BULLETIN NO. 33

JEFFERSON LAB

TECHNICAL ENGINEERING & DEVELOPMENT FACILITY
(TEDF TWO)

Bulletin No.33
Project No. 20080400
March 04, 2011

TITLE: TED BUILDING SECTION DETAILS			
SCALE	DRAWING NUMBER	SHEET	REV
3" = 1'-0"	100024-181-A163-STE	TED-A3.2.4.4	-

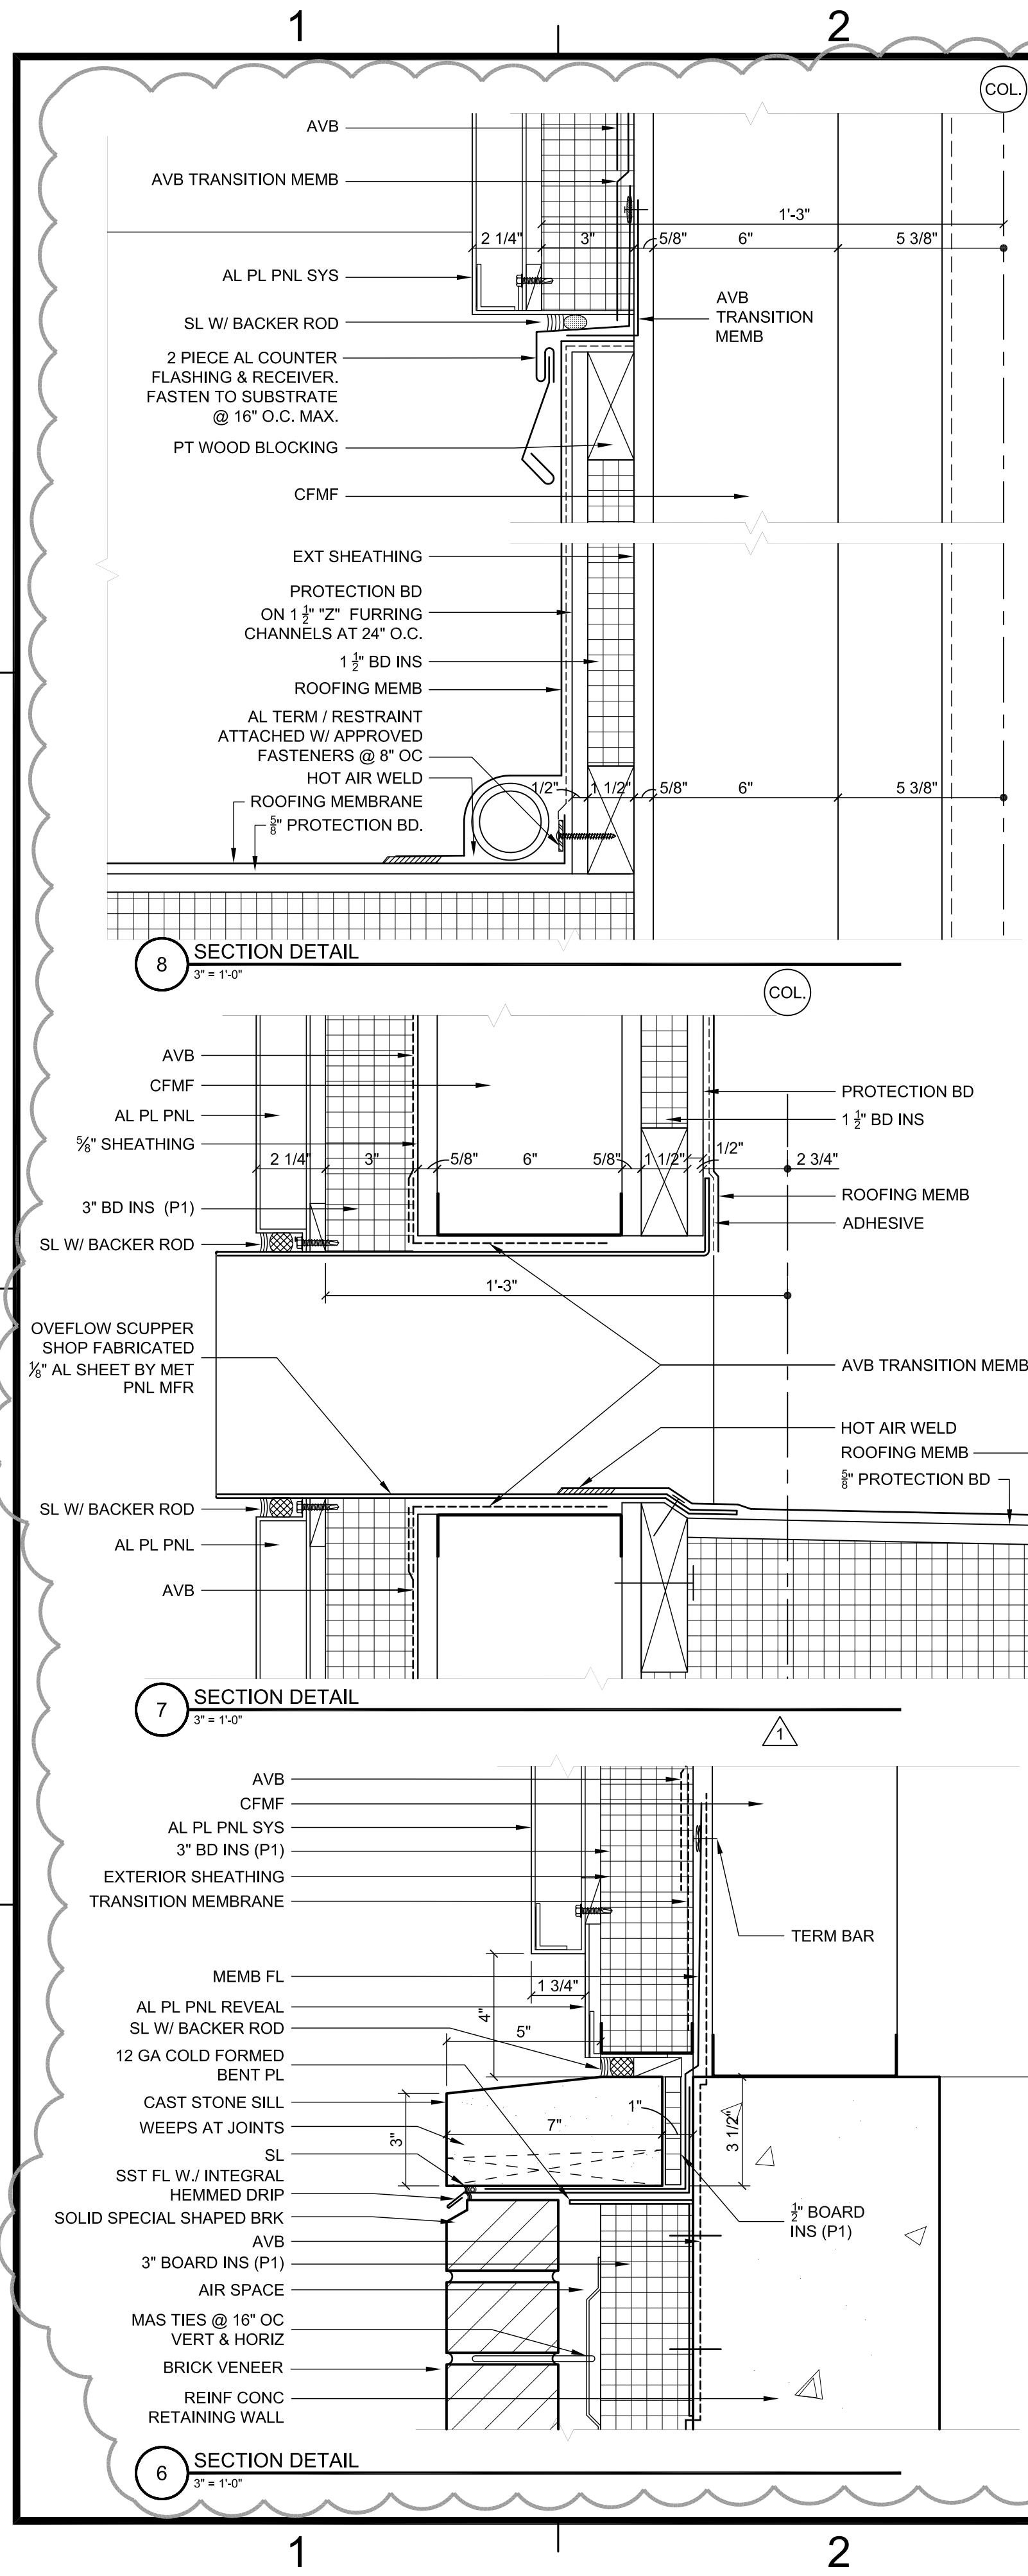
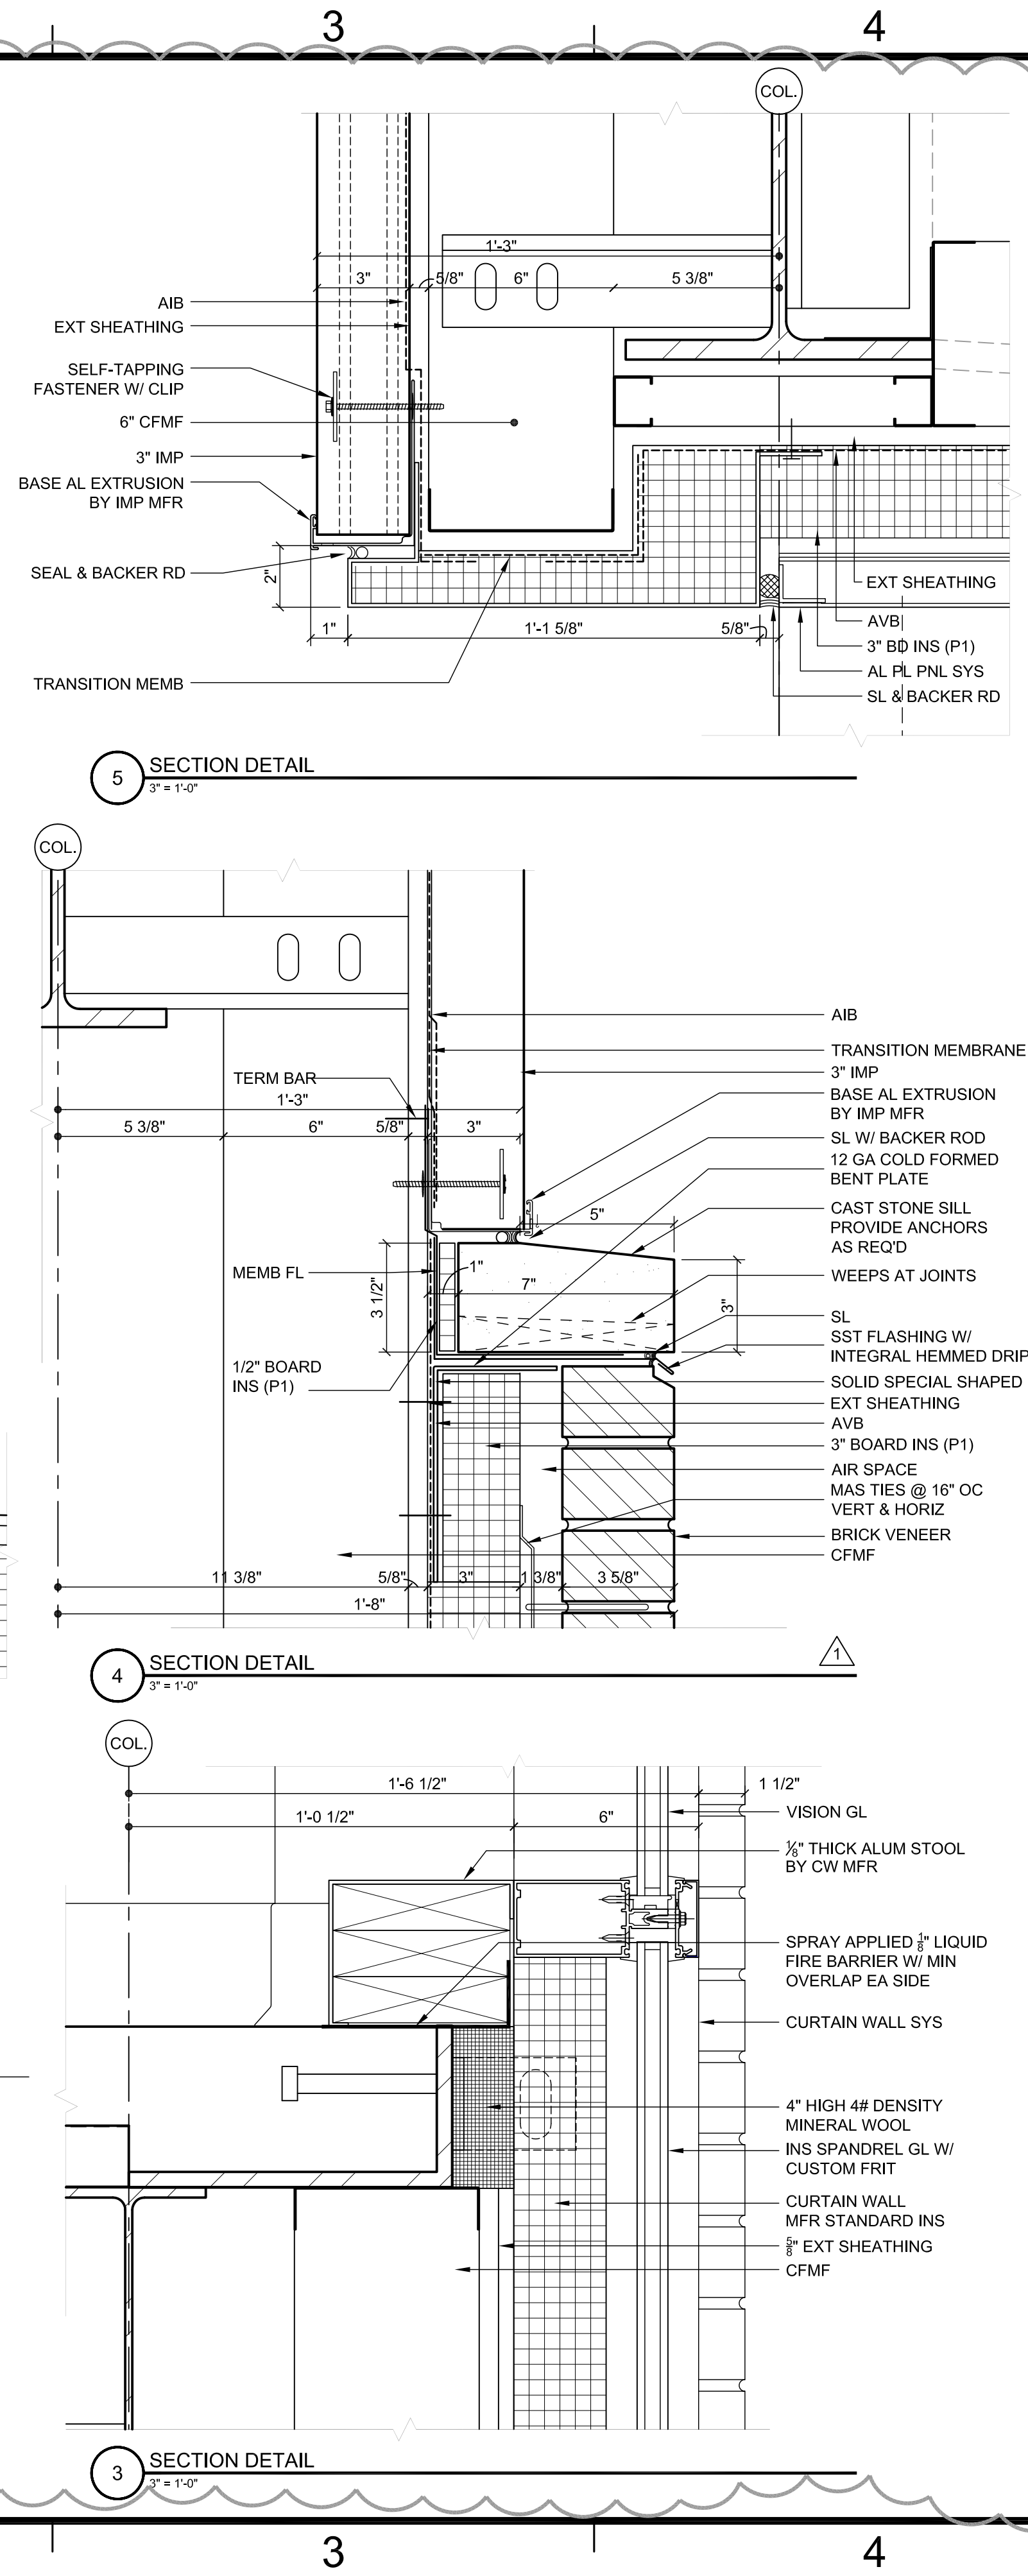
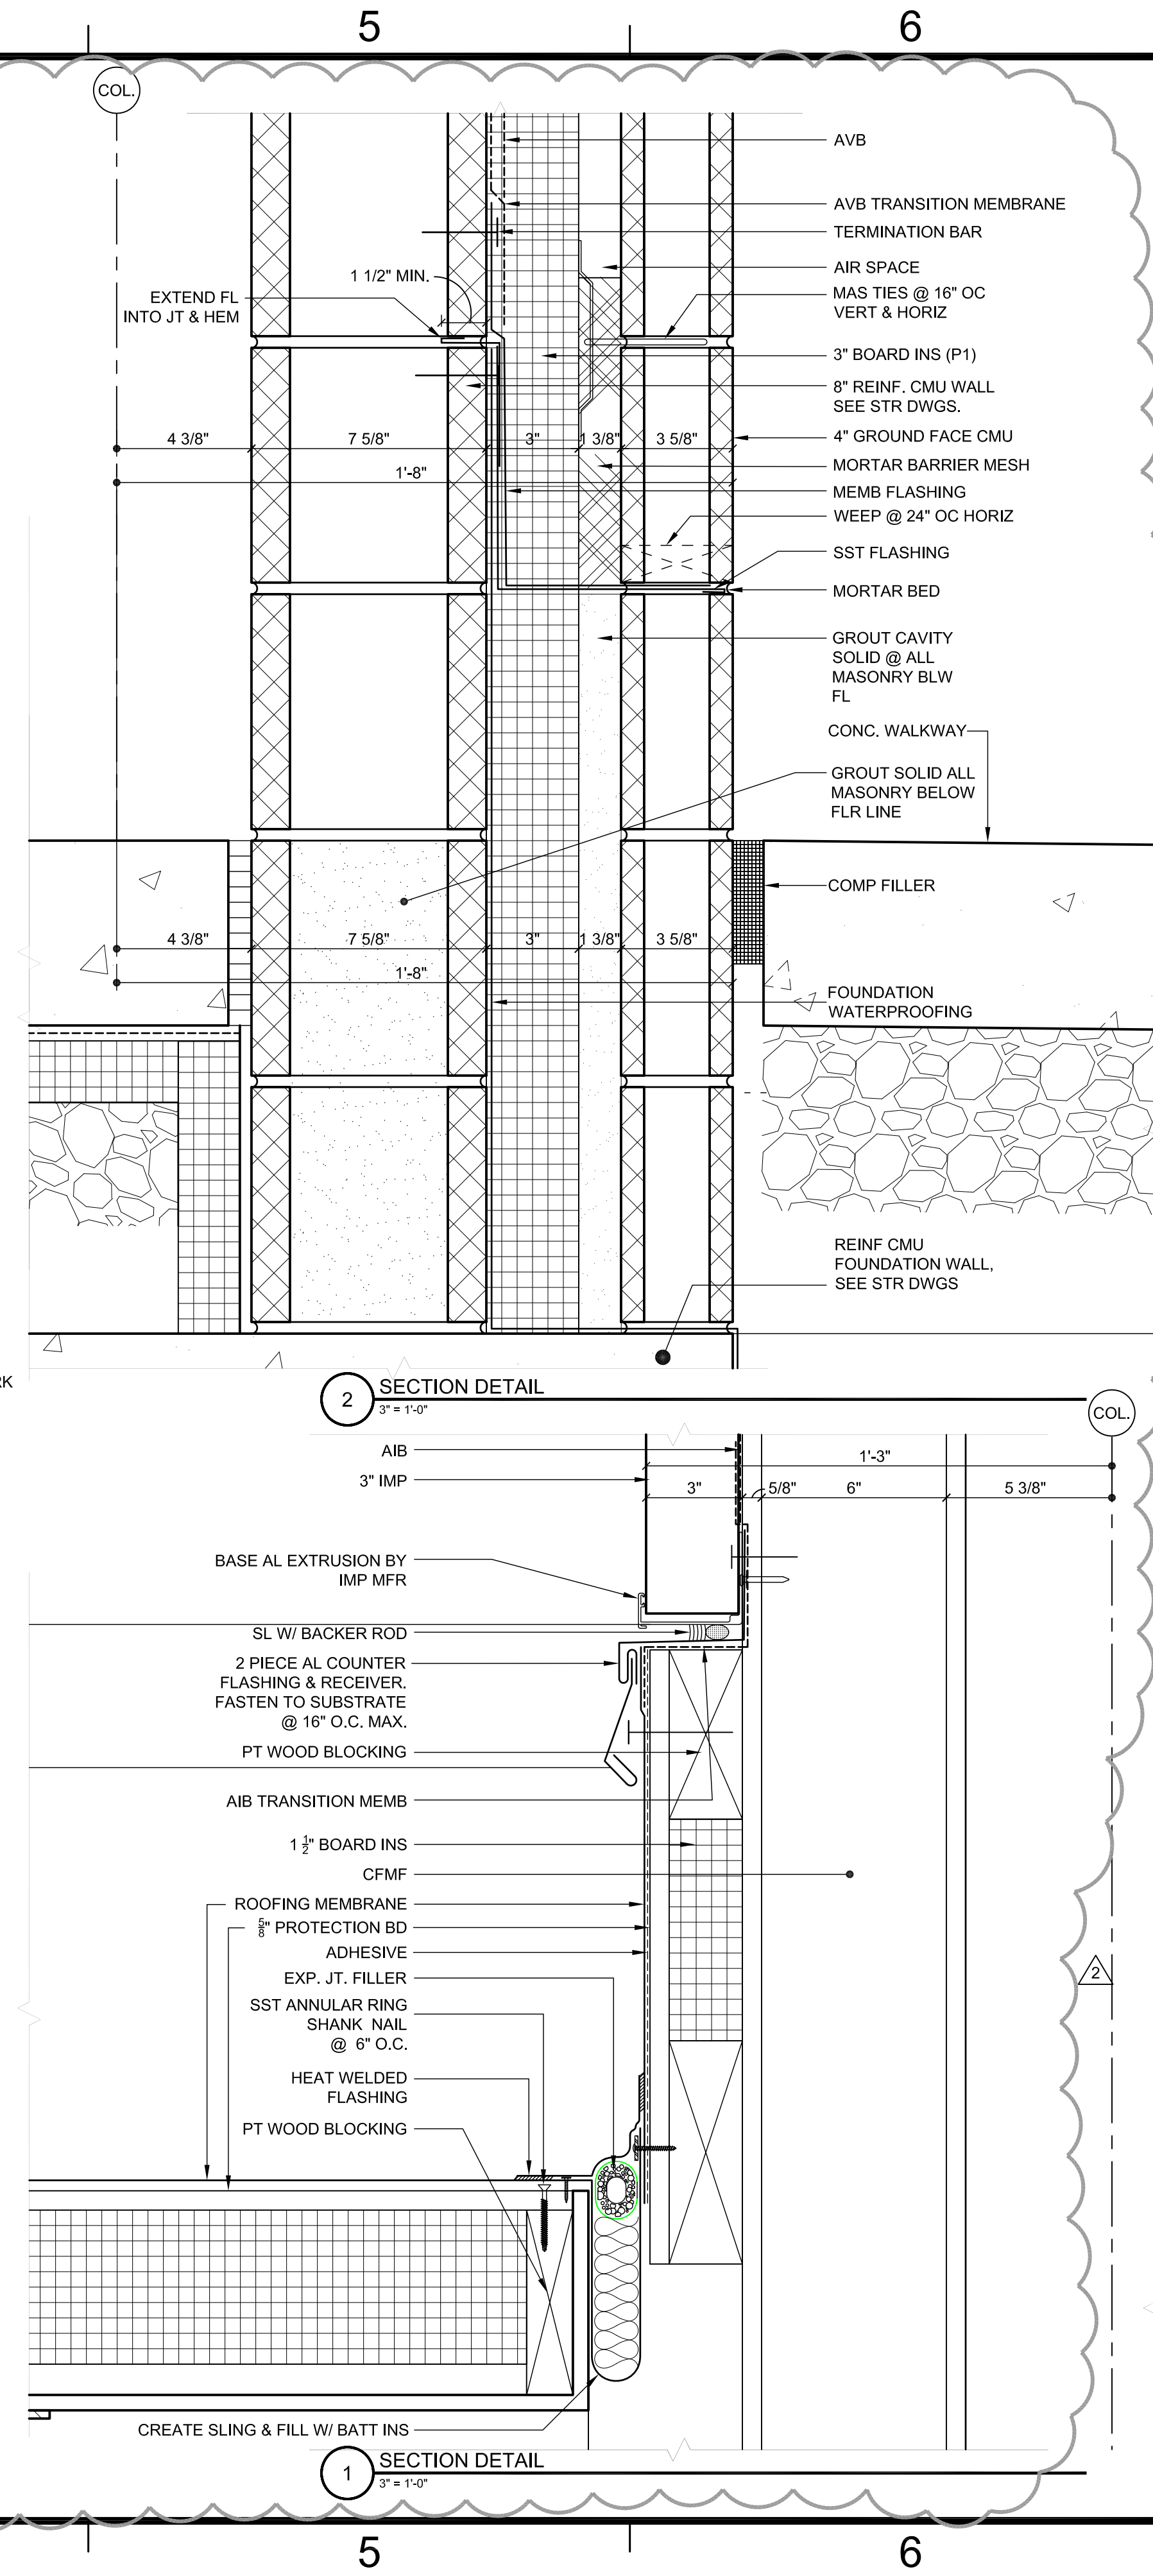
1. Revised section details
